Stream Flow Monitoring Report - Water Year 2023 – Salmon Creek

*Annex Creek/Salmon Creek Hydroelectric Project
(FERC Project No. 2307)*

Alaska Electric Light and Power Company

November 2023

Figure 5. Salmon Creek rating number 3 (log scale) used to compute discharge from December 1, 2020, through the 2023 water year.

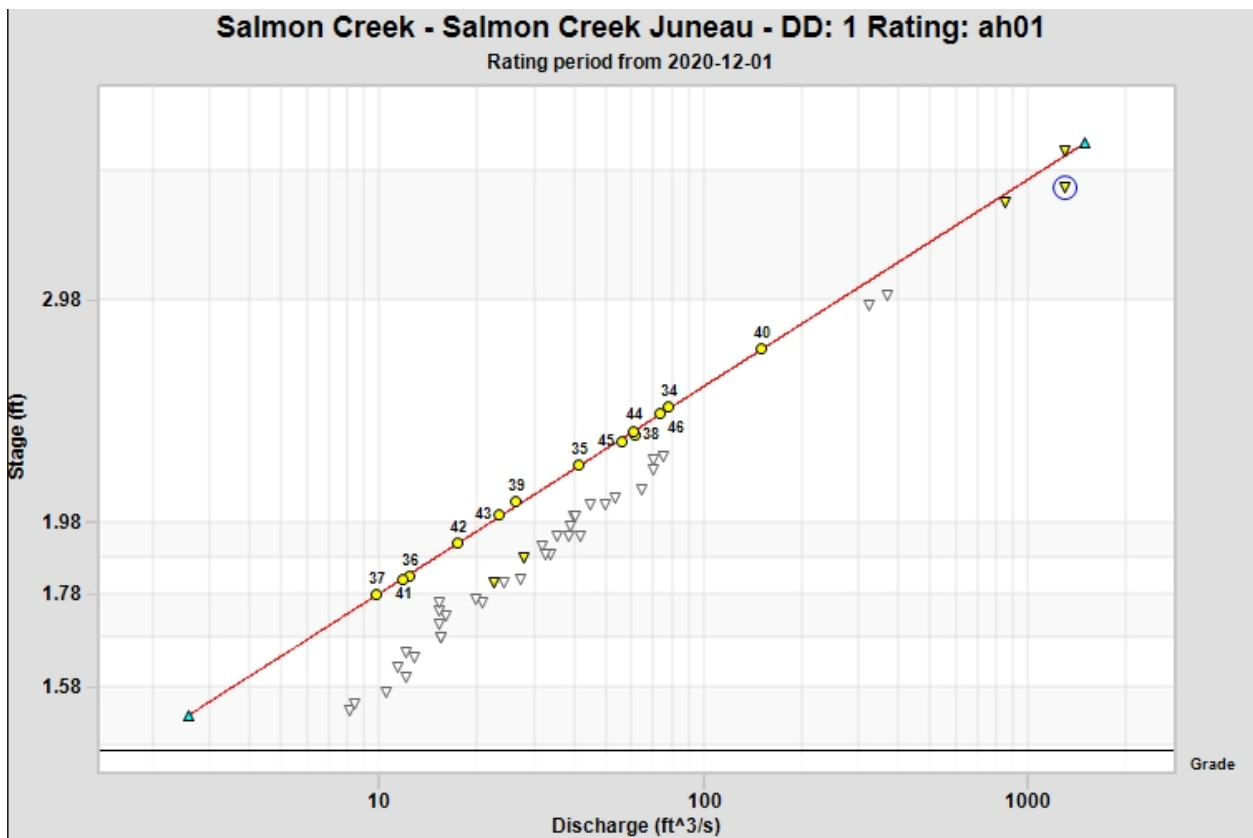
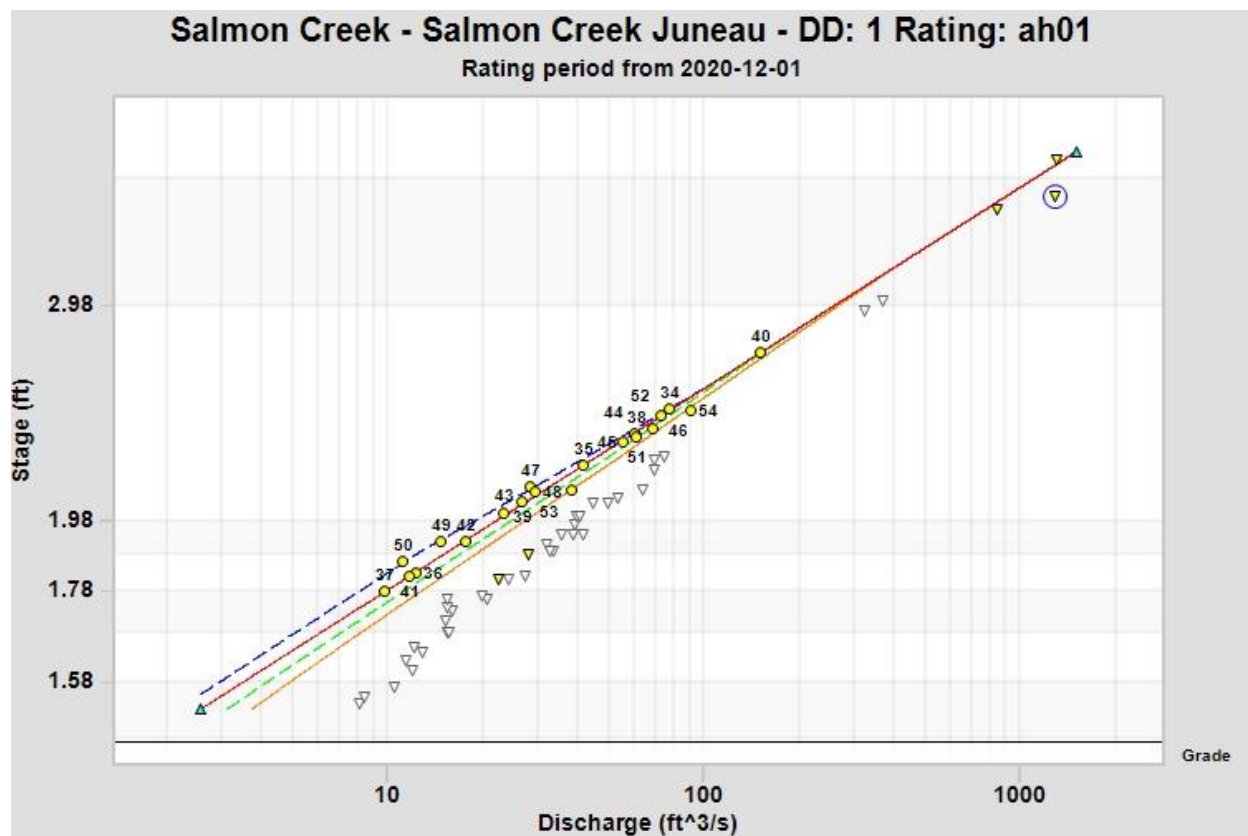
Thanks for the thorough water year report and for the opportunity to review. The streamgage operations appear to be going well. The only comment I have on the report is with Figures 5 and 6. There is a high flow discharge measurement that is circled on these graphs. It seems to be a measurement that was likely rated as poor, but it would be nice to have an explanation of this measurement in the remarks.

The three high measurements shown in this figure were all conducted by the USGS and I use them to define the high end of the rating. The circled measurement was just an oversight on my part. I had my cursor on that particular measurement when I made the plot. It doesn't really signify anything but an oversight on my part. The measurement was made several years ago, at least.

Please let me know if that doesn't answer your question. If the circle actually indicated something about the point I would add an explanatory note, but since it was simply where his cursor was located, I don't plan to make any change.
